First floor plan (typical floor plan)

C P	SENIOR ARCHITECT (SZ) I MADRAS - 8
W D	140, Marshall's road, Egmore, Madras - 600 008
	Dwg. no. SAISZ/IT/JDH/58
	Rev no. : 2
Scale: 1:50	TYPE III
Date: 5.3.80	BLOCK OF EIGHTS 8 STOREYED LOAD
File no.	REACTIVE WALLS
Sheet	First floor plan
Mananjyankarasi	
SENIOR ARCHITECT	SENIOR ARCHITECT
ARCHITECT	ARCHITECT

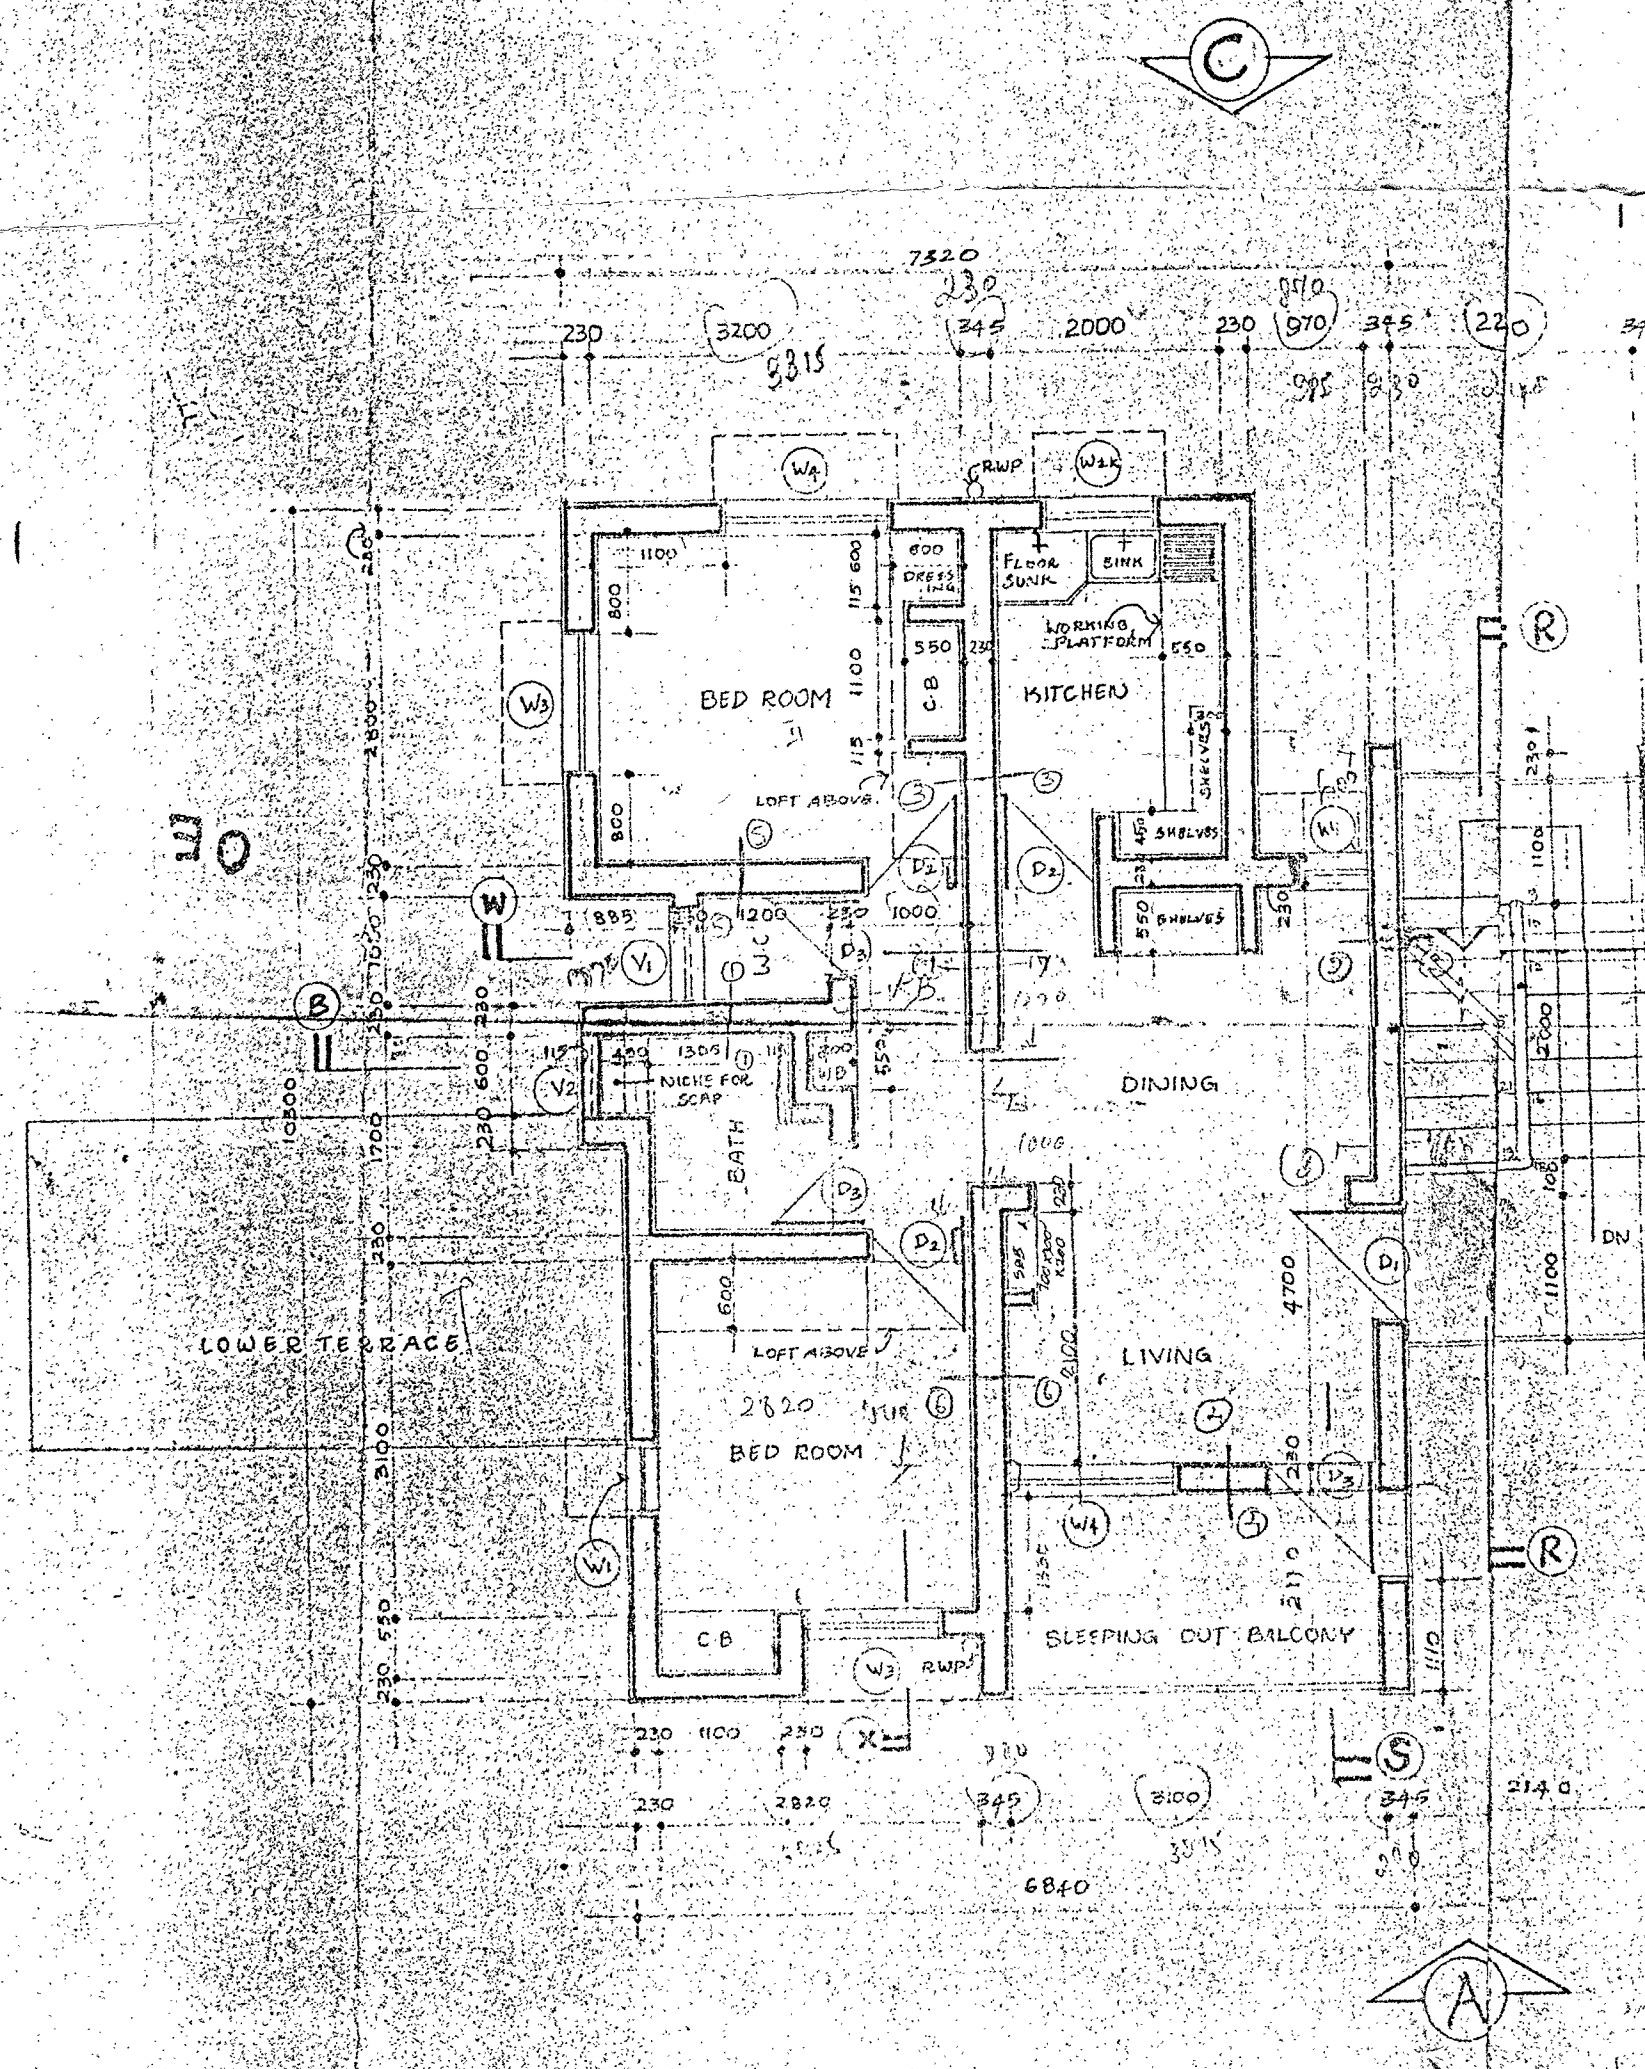
SL. NO.	REVISIONS	DATE	MADE BY
1	BLG. S.D.B. SHOWN AS PER L.A. NO. 22/1397/81/MCEC/NY 1528 dt. 1.4.81. RECD FROM: SE. CEJ, MCEC, CPWP, MADRAS.	5.4.81	Blasimadas
2	THIS Dwg. HAS BEEN MODIFIED AS PER L.A. NO. 23/771/81/MCEC/NY/2277 dt. 2.6.81. RECD FROM: SE. MCEC. THE WALL BETWEEN STAIRCASE & LIVING ROOM HAS BEEN REMOVED FROM 1.20 TO 1.25.	18.6.81	D. Hanumanth
3	2. MIDDLE LONGITUDINAL WALL BETWEEN BED ROOMS & LIVING, DINING, KITCHEN HAS BEEN CHANGED FROM 2.20 TO 3.35 UP TO FF. SLAB LEVEL ONLY.		
4	3. SIZE OF WASH BASIN OPENING HAS BEEN KEPT AS 550 X 300 MM.		
5	4. OPENING IN VERANDAH IS KEPT AS 1000 MM.
